CITY OF ALBUQUERQUE

**RE: APS Career Enrichment Center
807 Mountain Rd. NE
Requested for 30-Temporary C. O. - Accepted
Engineers Stamp Date 12/3/14 (J15D001)
Certification dated: 3-2-16**

GRADING PLAN

C-101

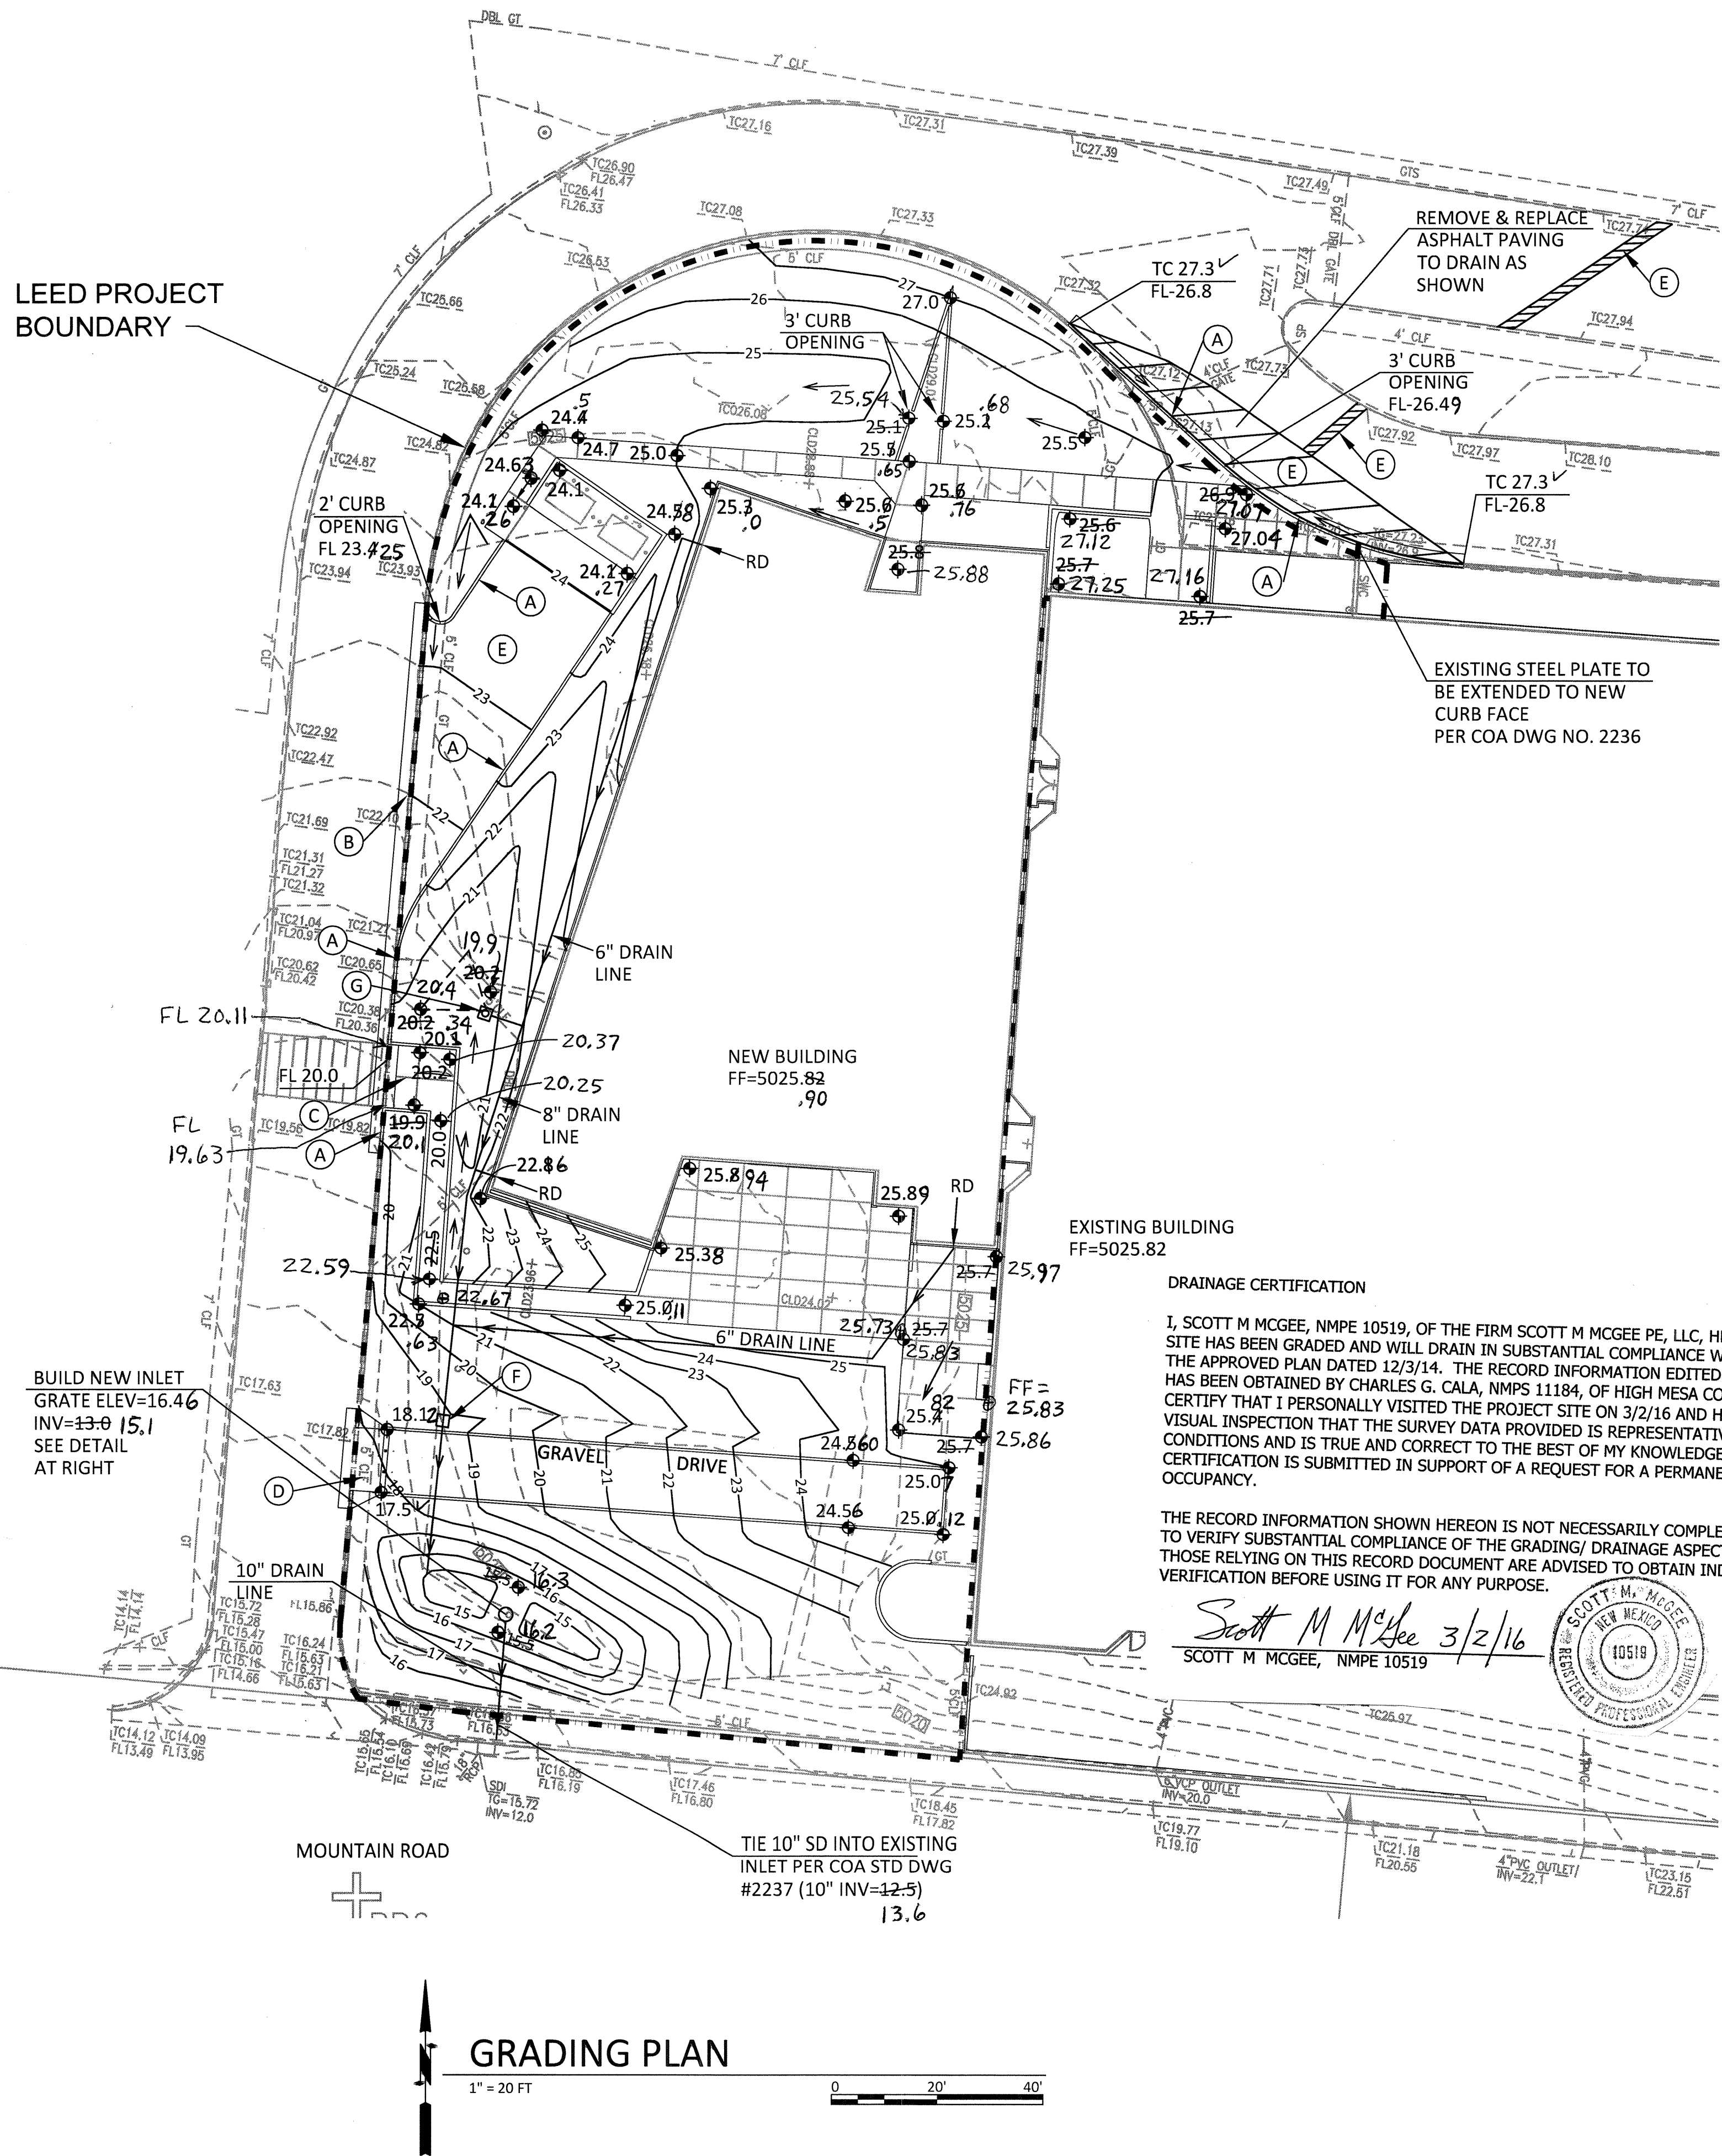
- On the north side of the building the existing steel plate has not been extended to the new curb face.
- On the drawings there is a roof drain called out on the south side of the building. That area is behind a locked enclosed area and I was unable to verify the roof drain.
- There is an existing manhole south of the new pond with the cover tipped up presenting a hazard.
